# MEMORANDUM

**FILE NO.:** VAR2012 0033

**PROPOSAL:** Request for height variance from required 35 feet to 47 feet for proposed dormitory.

A2- HEIGHT VARIANCE CALCULATIONS: Height Variance 11'- 10 1/2" (12'-0" , for simplicity)

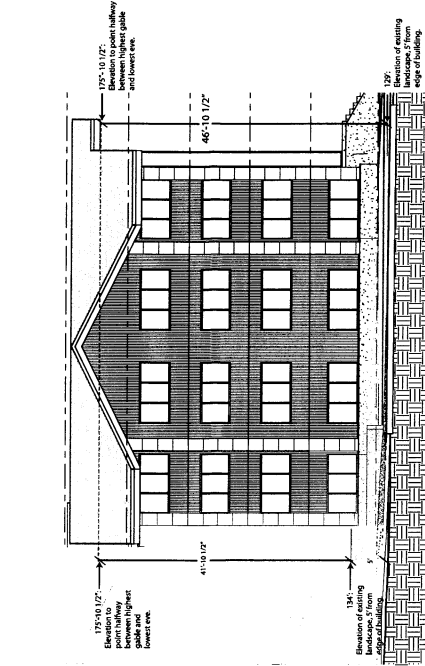
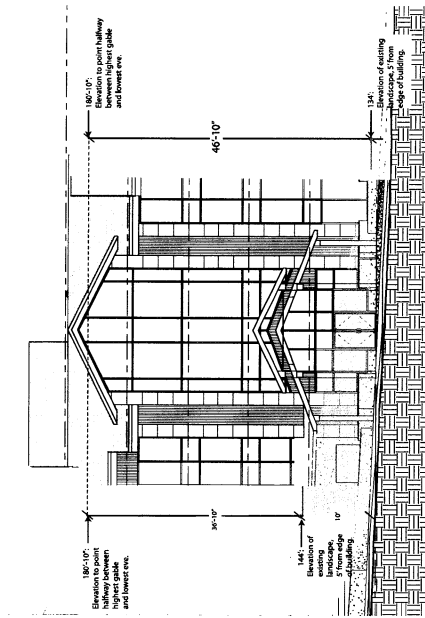
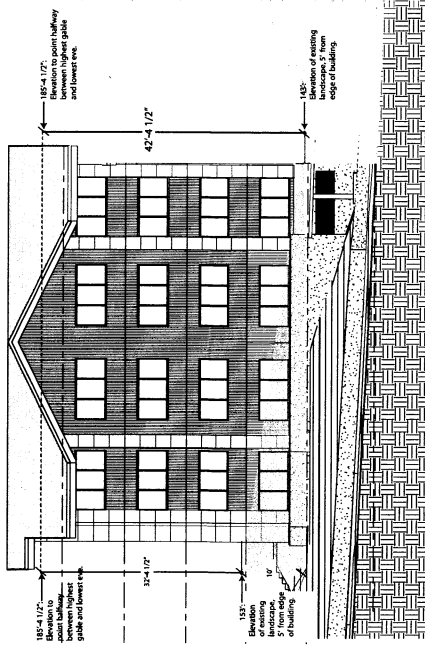
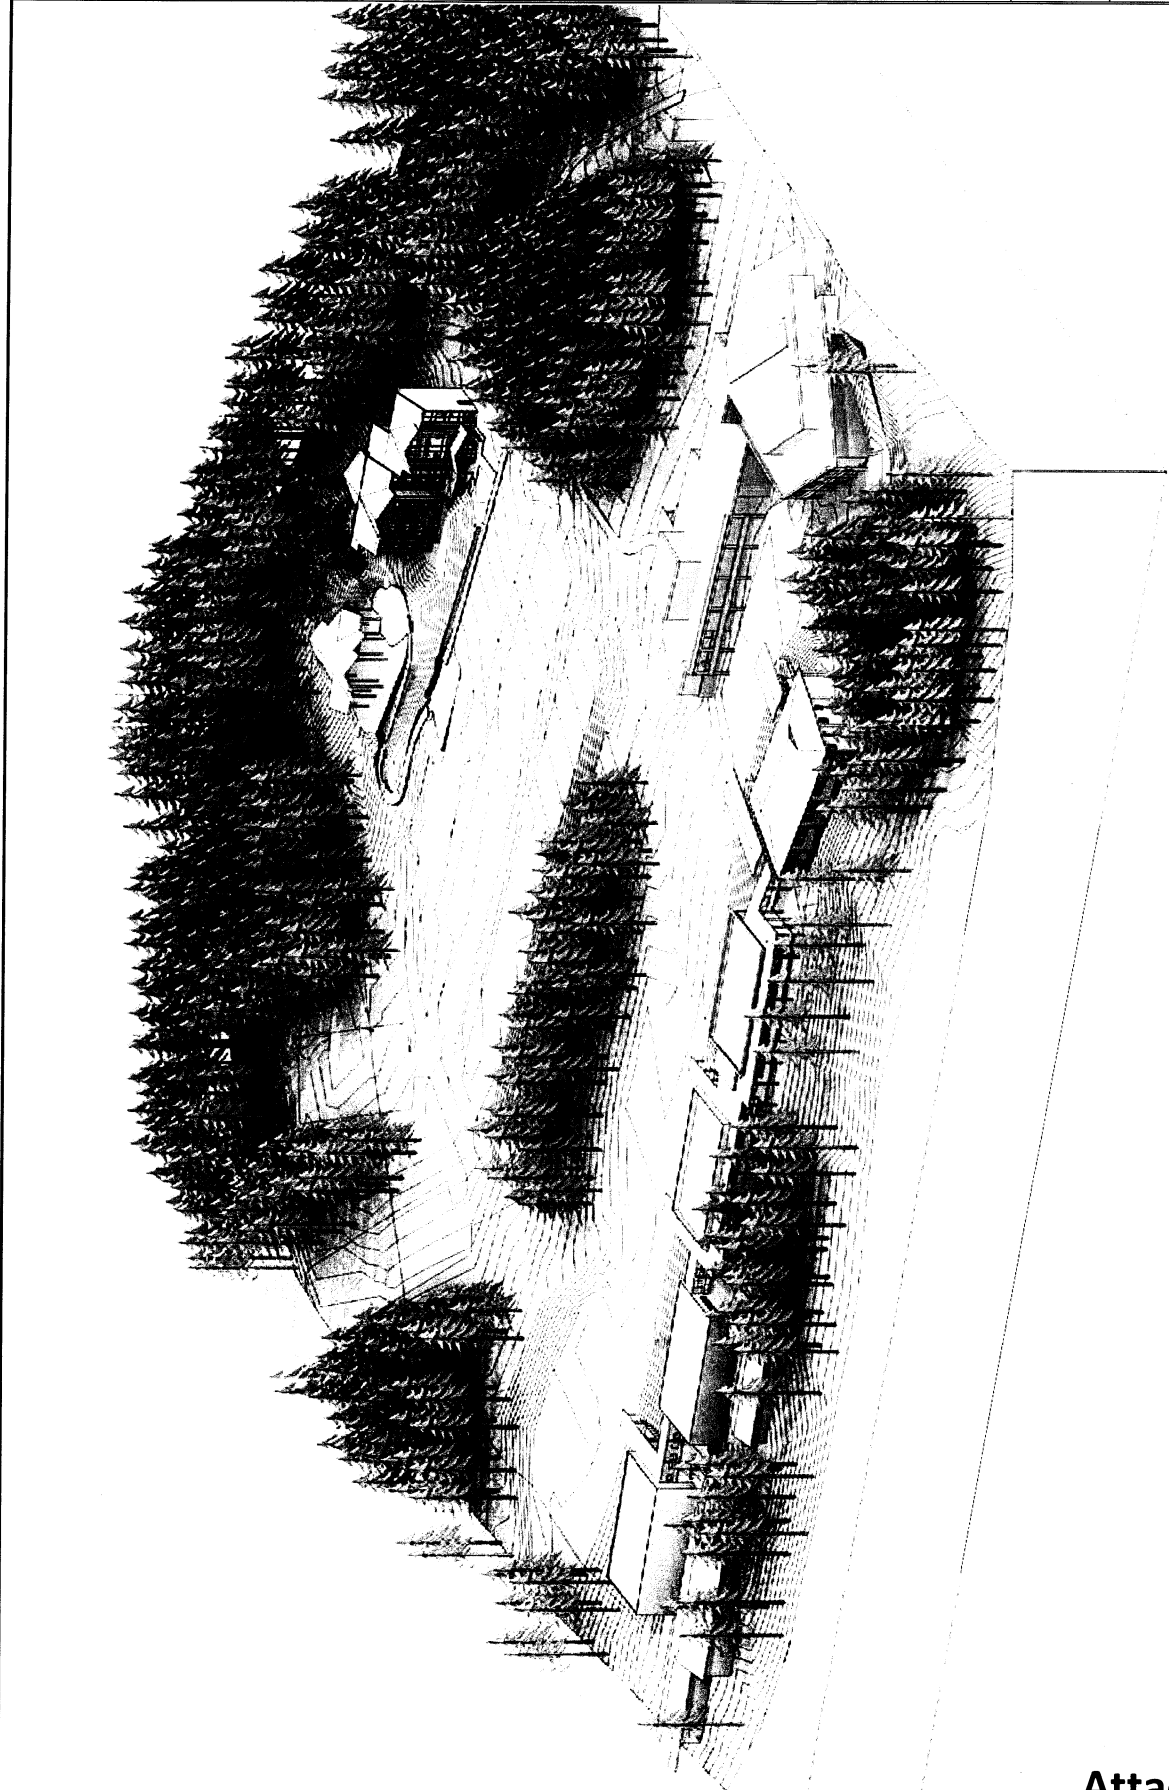
According to the application materials, phase 2 of the project is the highest at just under 47 feet, just about 12 feet higher than the maximum height of 35 feet allowed in the D5 zoning district (attachment B). The building is designed to set into the hillside. The five story building has been designed to create a smaller building footprint so as to minimize disturbance of the site and existing trees. The application and associated drawings indicate that the roofline of the proposed dormitory will be similar to that of the Noyes Pavilion when viewed from the parking lot (attachment C & D).
